Watts Bar Nuclear Plant, Unit 2
NRC Docket No. 50-391

**Subject: Watts Bar Nuclear Plant (WBN) Unit 2 – Safety Evaluation Report
Supplement 22 (SSER22) - Response to NRC Required Action Items**

ENCLOSURE 1

Response to Action Items From Appendix HH of NUREG-0847, Supplement 22

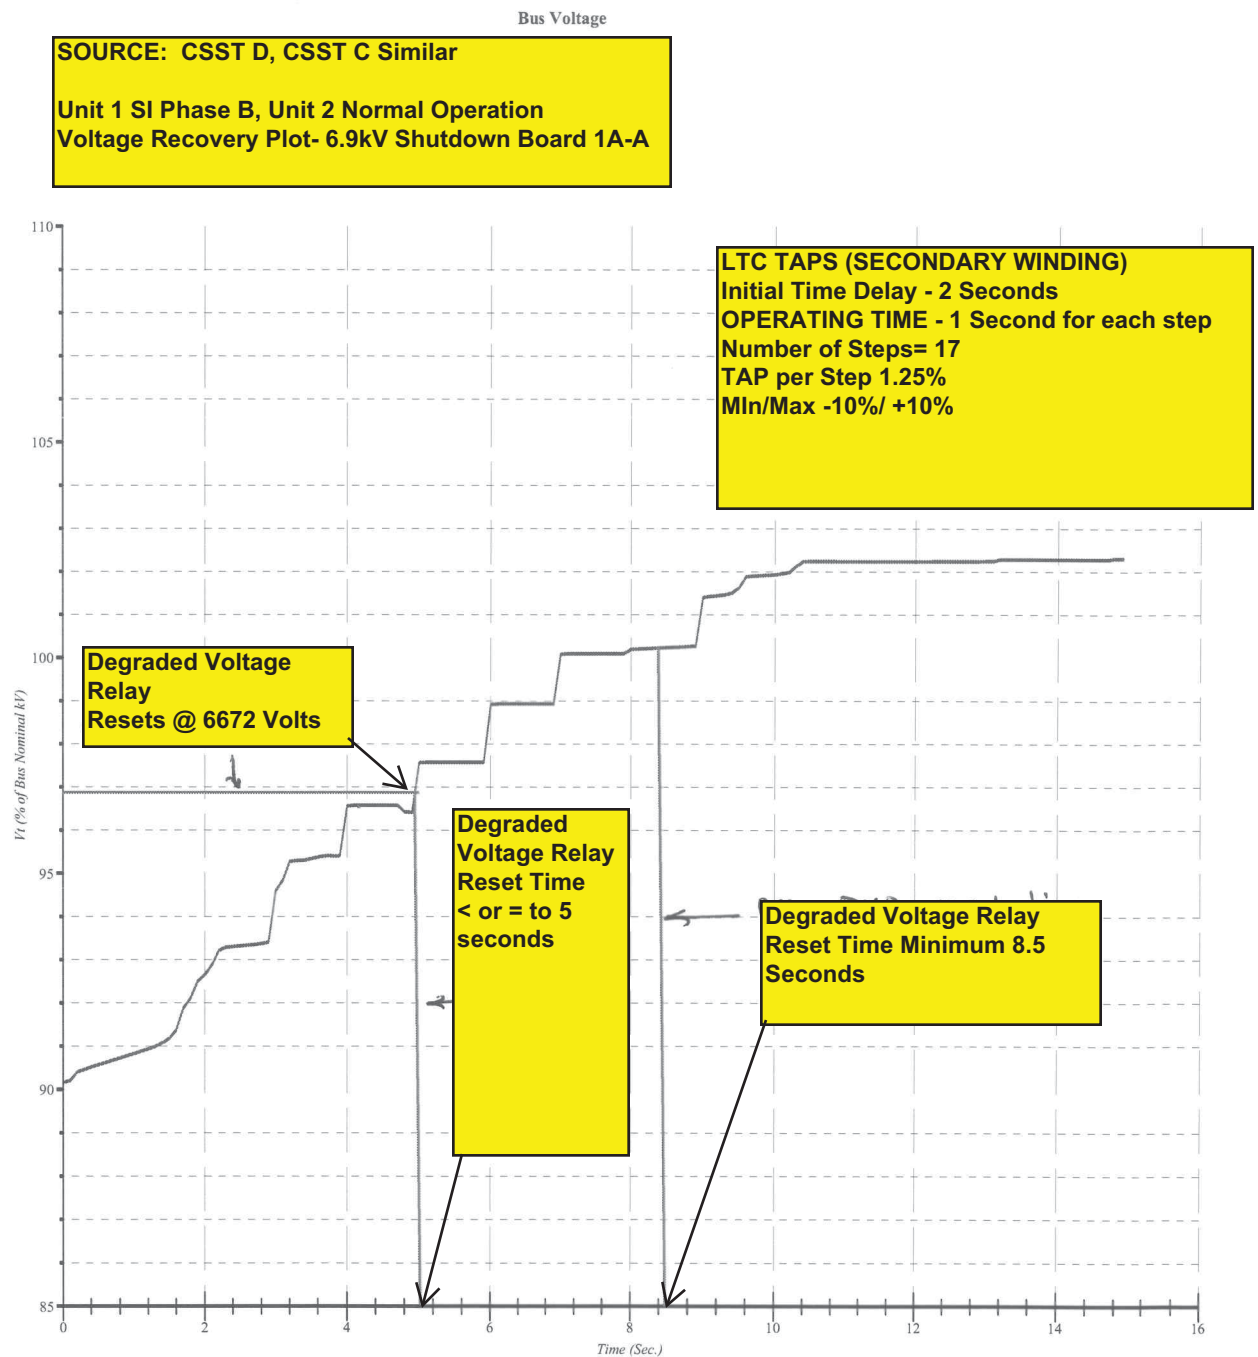
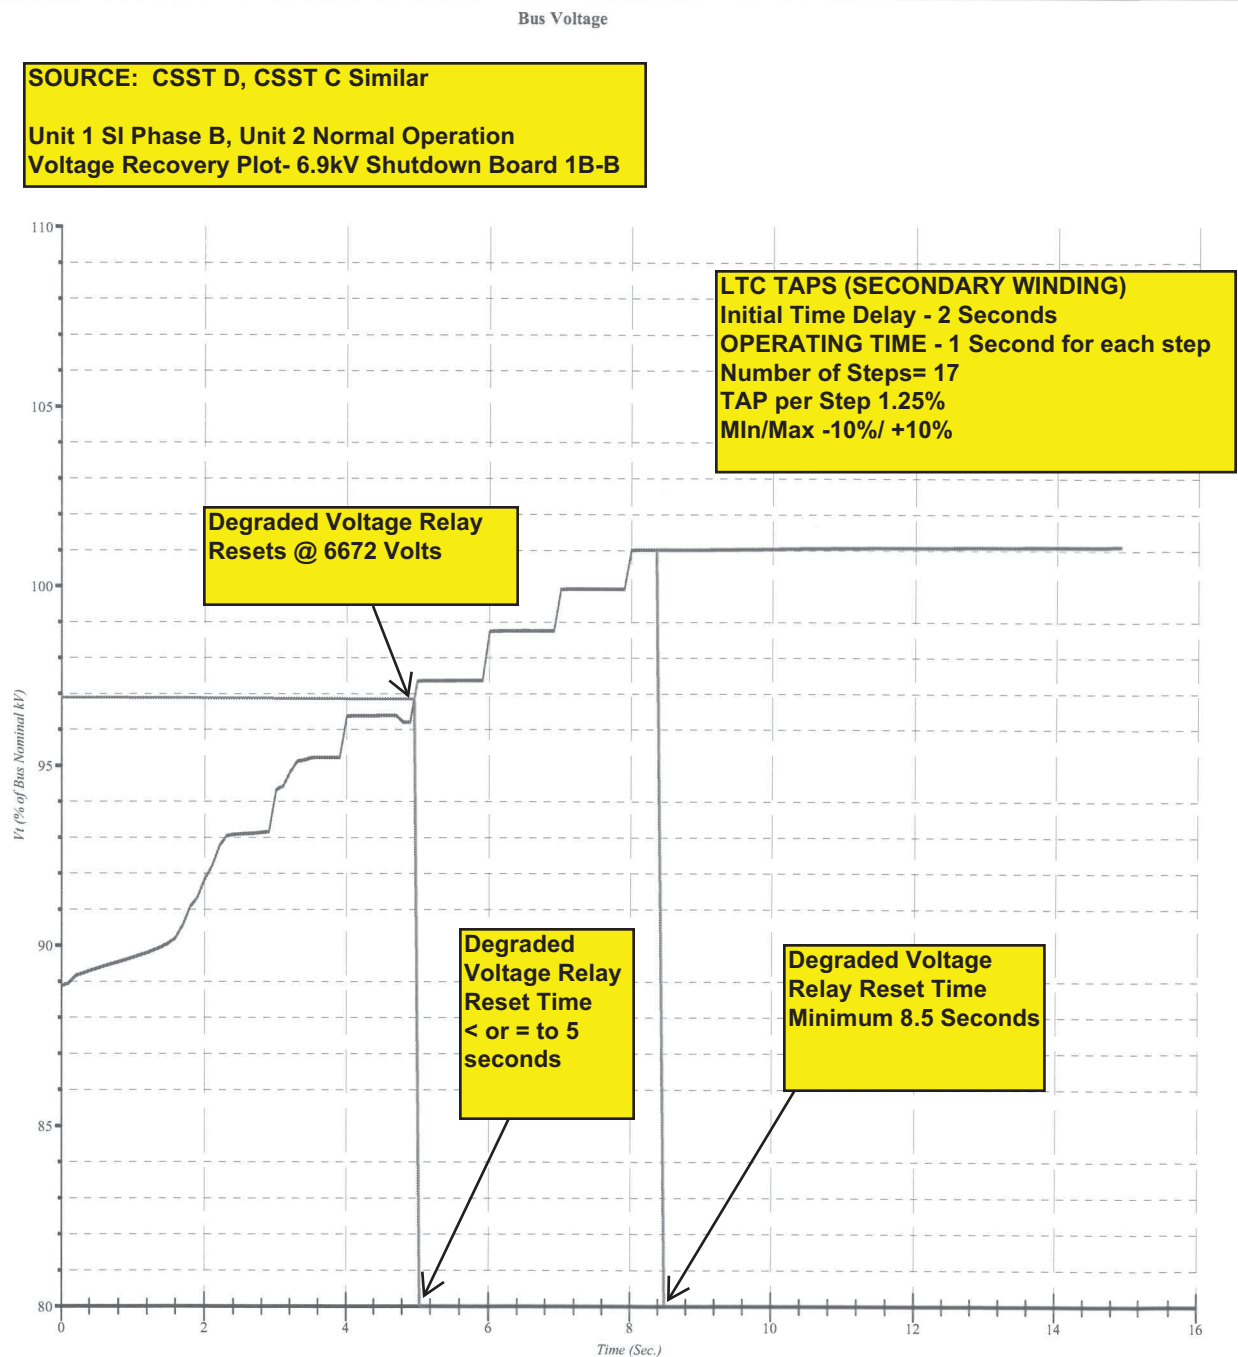
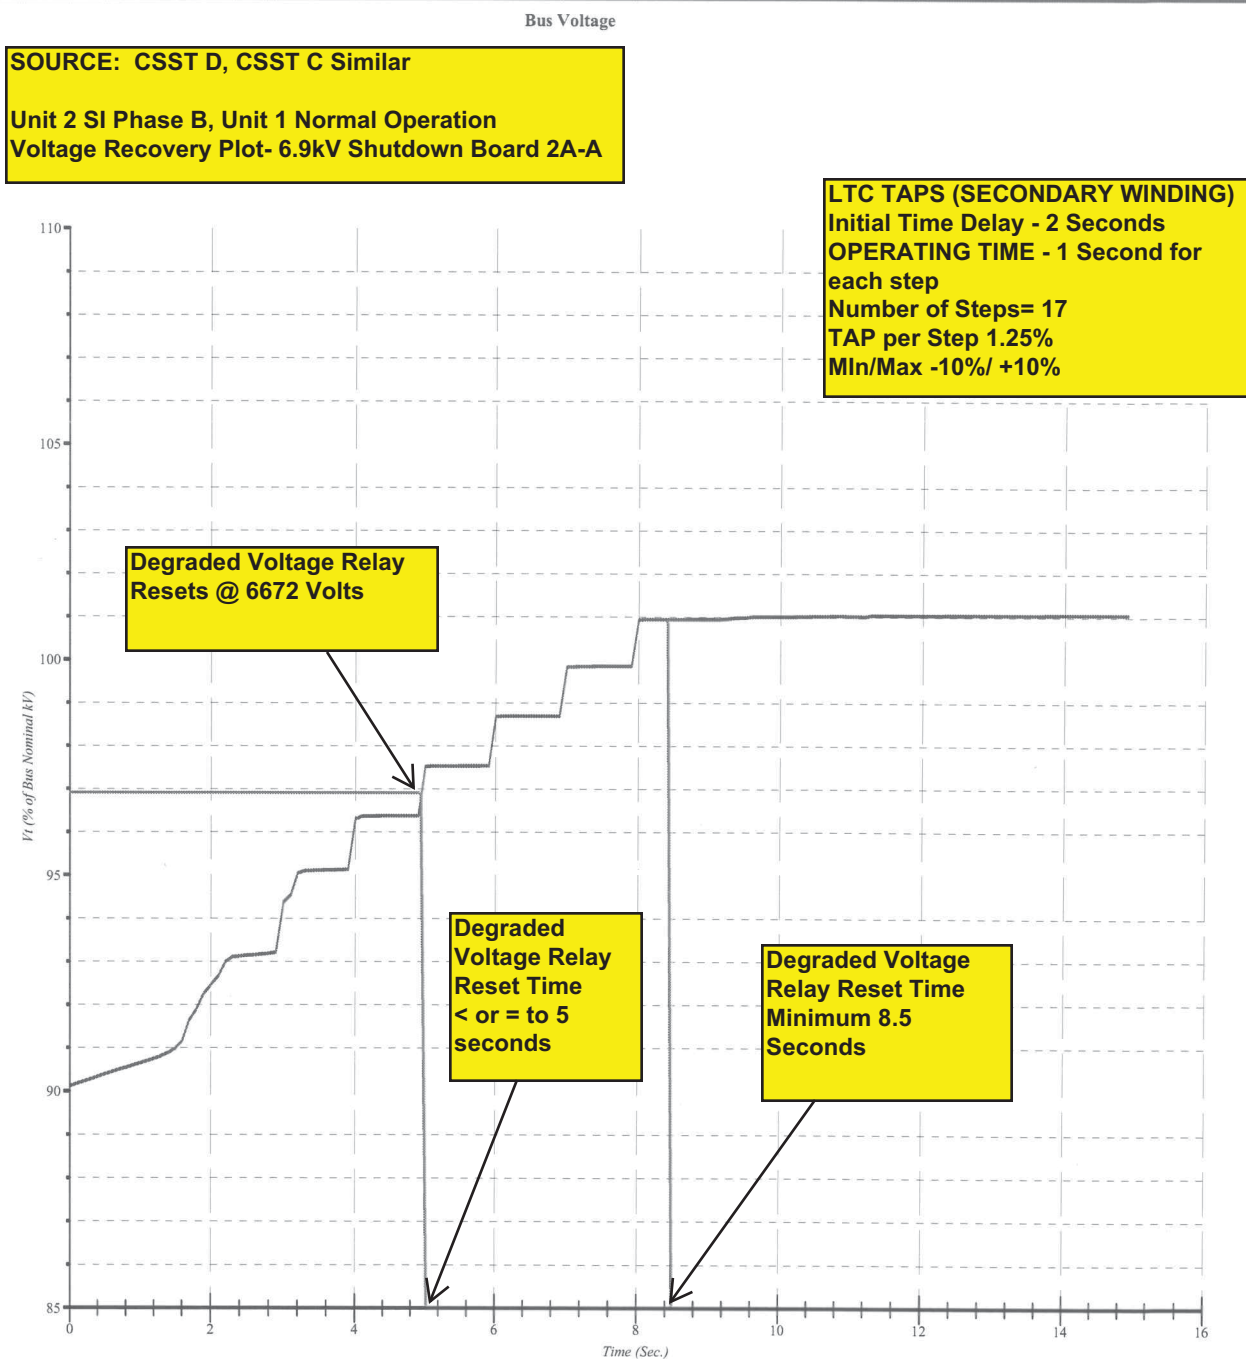
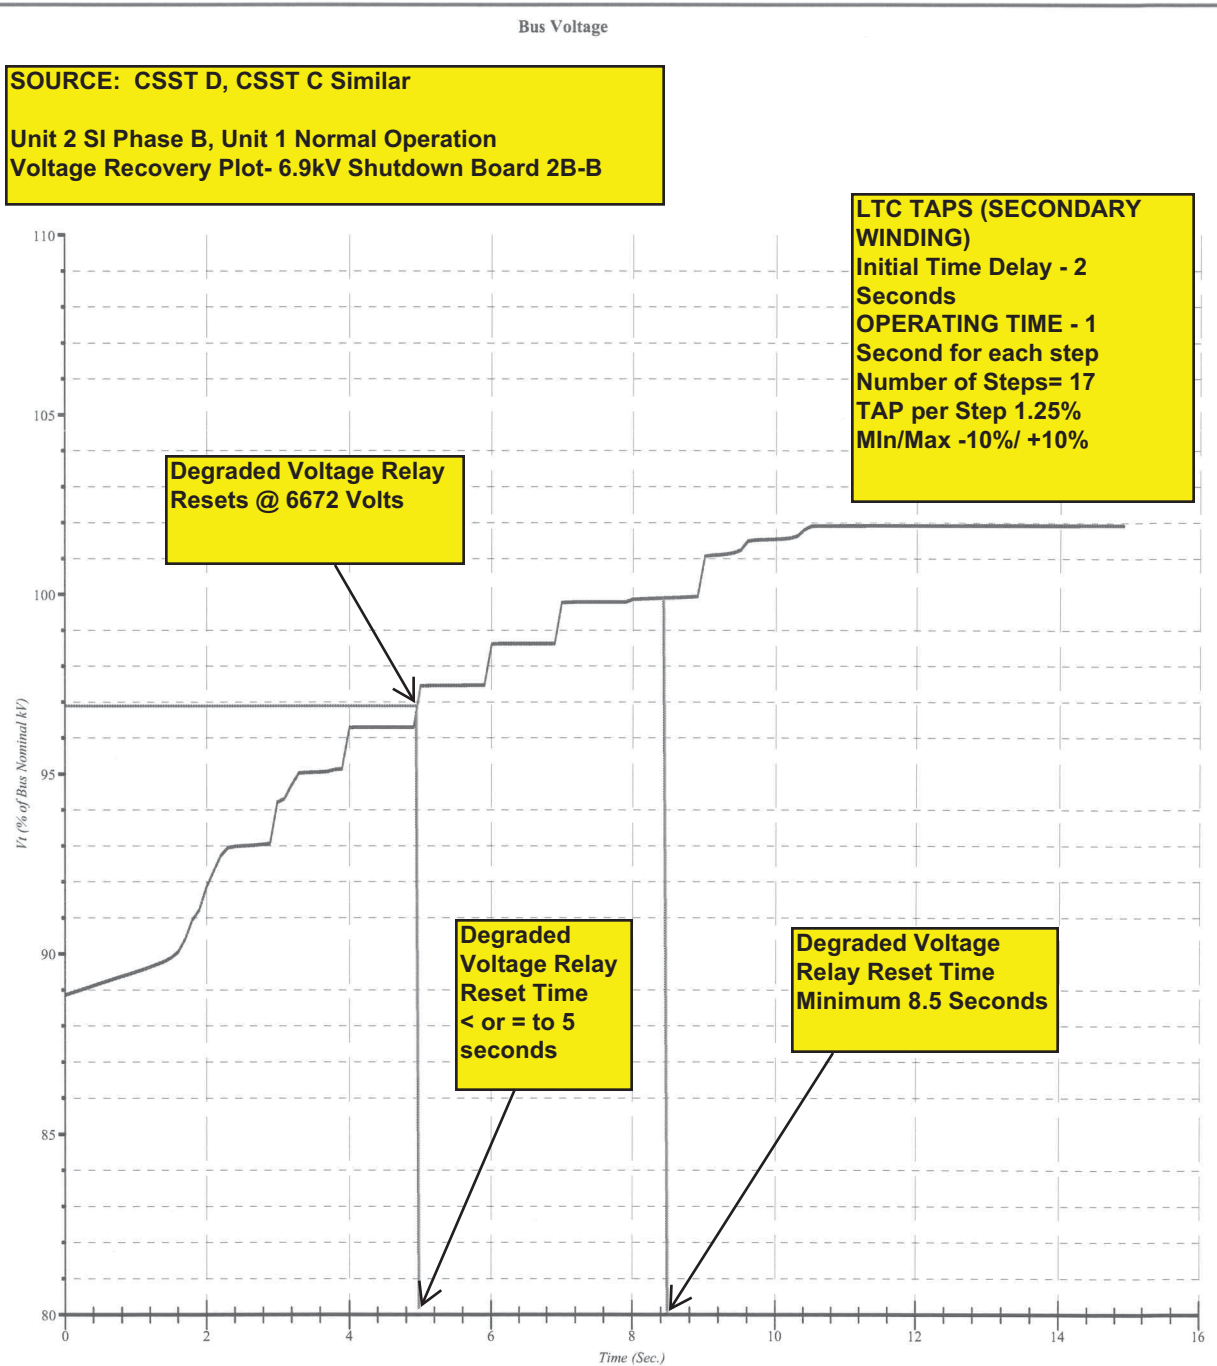
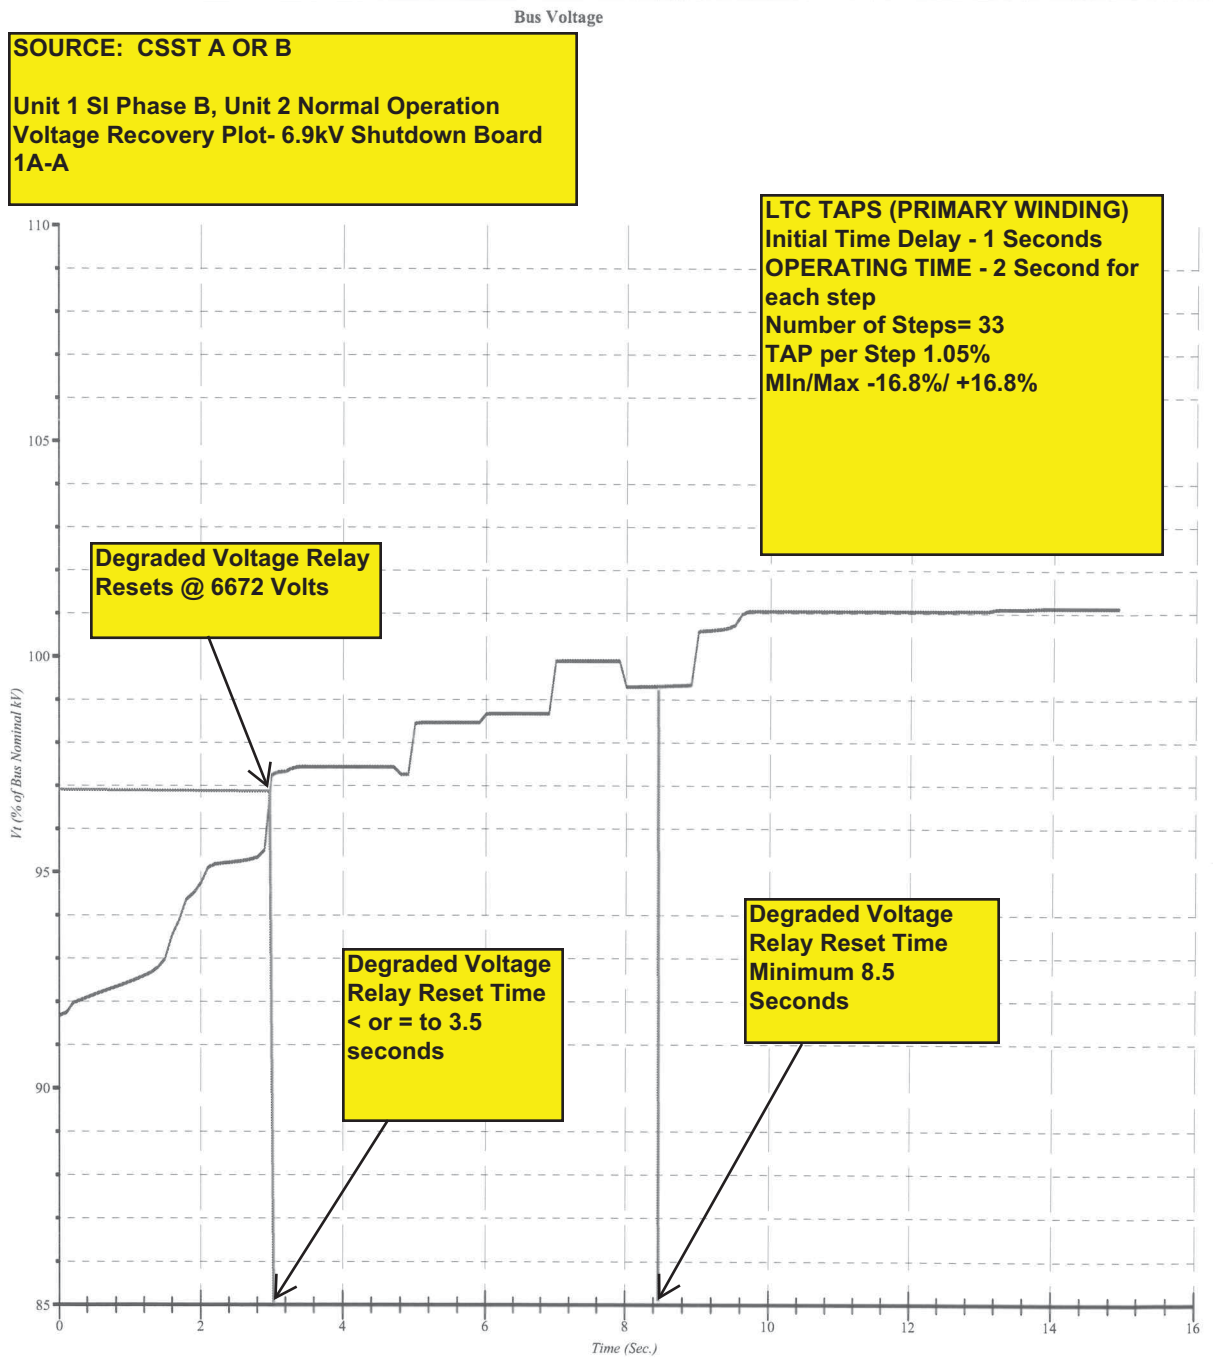
28. *TVA should provide to the NRC staff a detailed discussion showing that the load tap changer is able to maintain the 6.9 kV bus voltage control band given the normal and post-contingency transmission operating voltage band, bounding voltage drop on the grid, and plant conditions. (Section 8.2.2)*

Response: For CSSTs C and D, the load tap changer (LTC) is set to regulate 6.9kV shutdown board voltage at 7,071V (102.5%). For CSSTs A and B, the LTC is set to regulate the voltage at the 6.9kV start buses (which can power the 6.9kV shutdown boards through the 6.9kV unit boards) at 7,071V (102.5%). The upper and lower setpoints of the dead bands are 7,132V (103.4%) and 7,010V (101.6%), respectively. The dead band considered is $\pm 82.2V$ equivalent to the operating tolerances identified for these setpoints. The LTCs have the following parameters:

The analysis evaluates the 6.9-kV shutdown board minimum voltage requirements considering a maximum (bounding) grid voltage drop of 9 kV and a minimum grid voltage of 153kV and all plant conditions. Although the calculated shutdown board voltage falls below the degraded voltage relay dropout setpoint due to block start of ESF motors, it recovers above the degraded voltage relay reset setpoint in ≤ 5 seconds. The minimum time for the degraded voltage relays to isolate the offsite power from the 6.9kV Shutdown Boards is 8.5 seconds.
